IFB No. 16-49 Washington Academy Renovations

RE: ADDENDUM NO. 2

Subject: **CHANGES to the BIDDING DOCUMENTS**

Project: **RENOVATIONS TO
WASHINGTON ACADEMY
ROCKFORD PUBLIC SCHOOLS
ROCKFORD, ILLINOIS**

JOB NO. 15-021 ADDENDUM DWG.
DATE: APRIL 15, 2016 **ADM2.2**

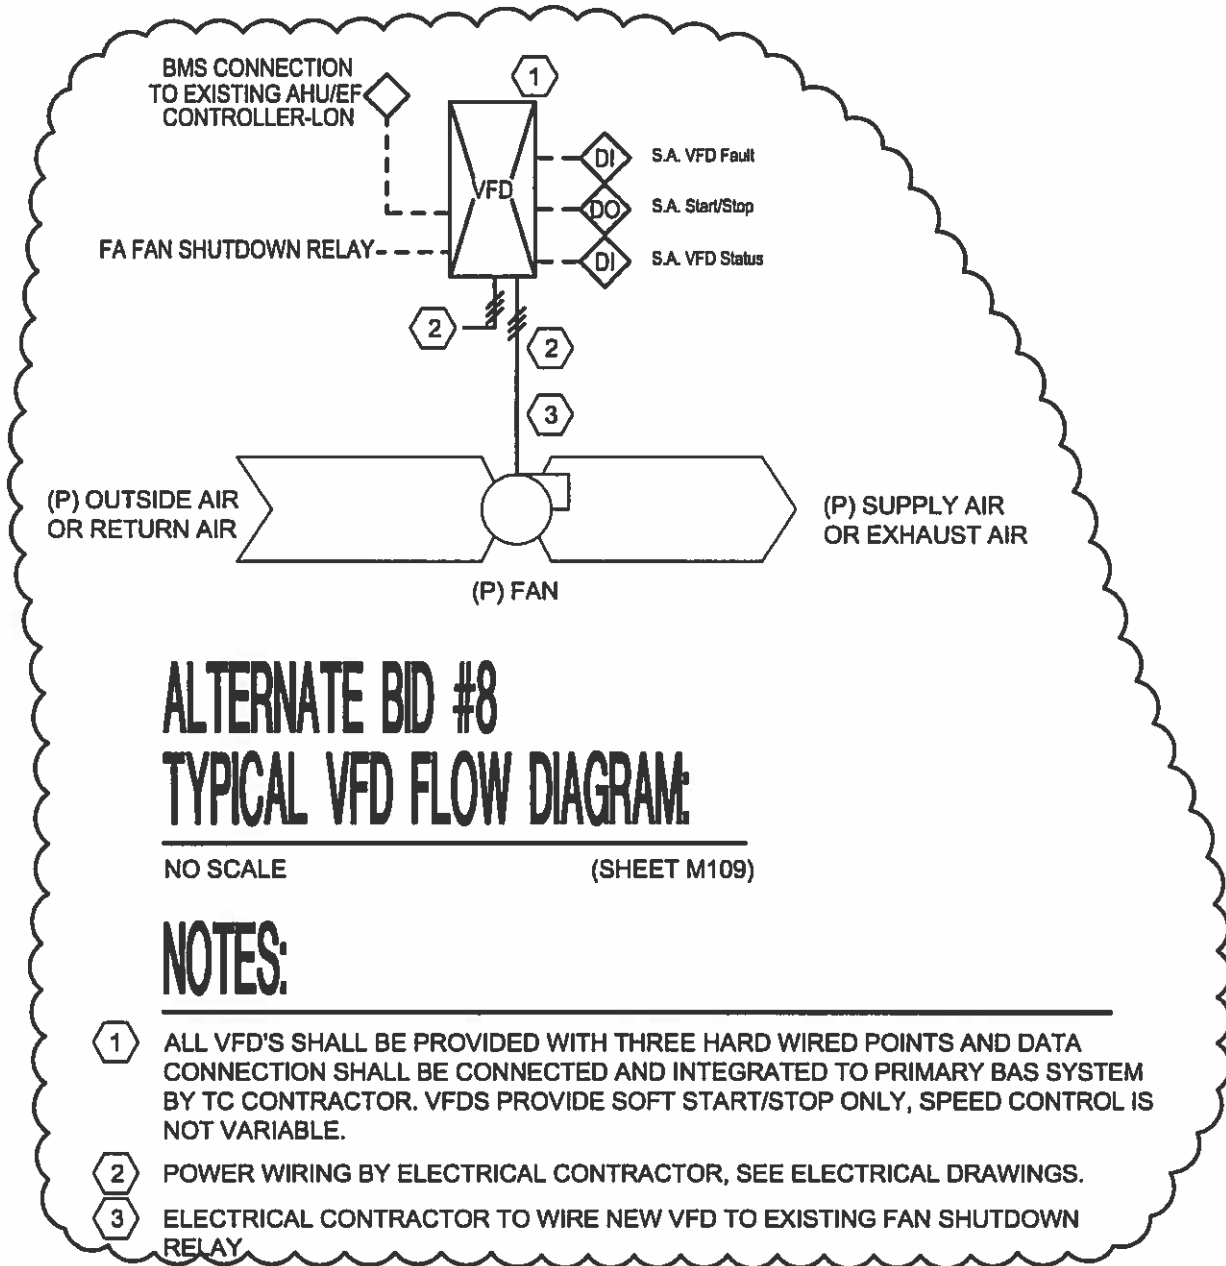
- 6.1. See attached drawing ADM 2.2 – Revised Controls Diagram replaces controls diagram on Sheet M113.

ADM2.1

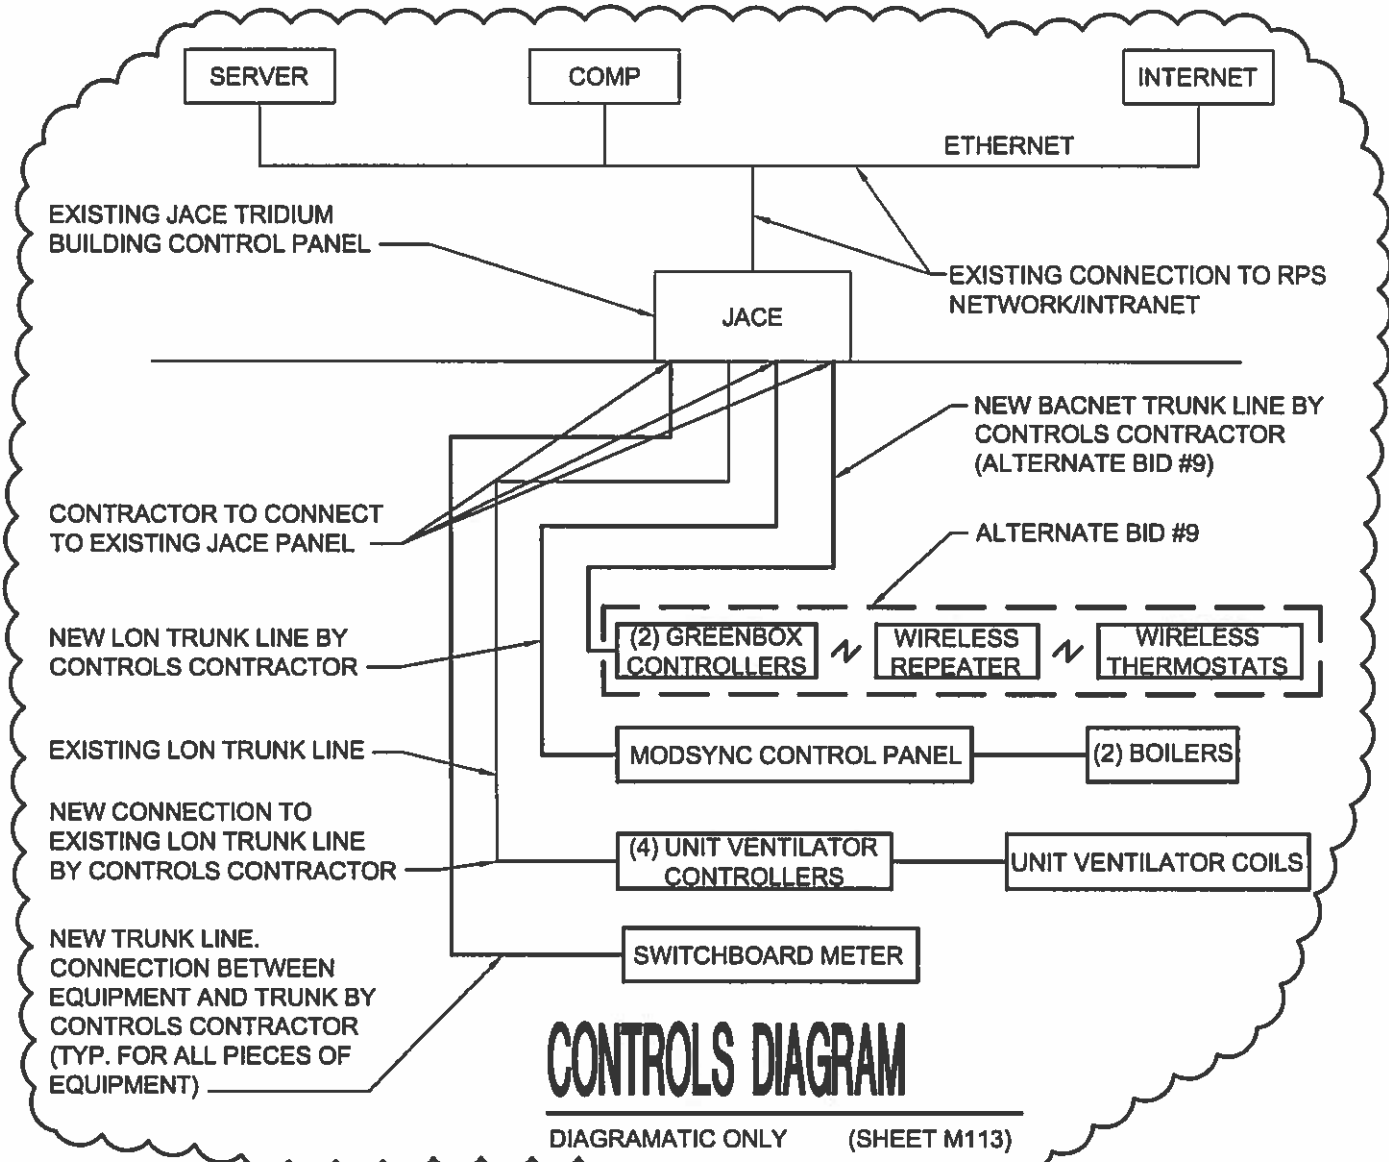
4.3. Question - Alternate Bid #8 adds VFDs and Drawing M109 outlines control point tied to each VFD. What controls the VFD speed? Are there existing controllers with enough point capacity to add the VFD points? Or do we need to add a controller? Equipment to receive new VFD include S-1, E-1, S-2, S-3, E-3.

- 5.1. See attached drawing ADM 2.1 – Revised VFD Flow Diagram replaces flow diagram on Sheet M109.

Answer – VFDs are used for soft start/stop only; speed is set at start-up and is not variable. Controllers are existing and points are available, see revised VFD flow diagram on Sheet ADM2.1.
